Access Compliance Report Public Rights-of-Way (Pedestrian Signals)

Main Street: **CHIQUITA_CANYON_DR** Cross Street: **CHIQUITA_CANYON_DR** Location: **N**

ADA ID: **SGRK211130120850** Signal Type: **One Push Button-APS** Overall Compliance: **No** Severity Scores: **BTN 1: 25** **BTN 2: N/A** **No BTN: N/A**

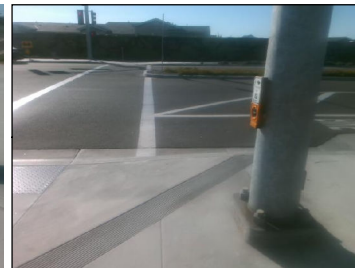
OC Std/PROW: MUTCD 4e.08, R404.2, R404.3

Possible Solutions: Replace Signal Push Button With APS Button. Remove & Relocate Sign.
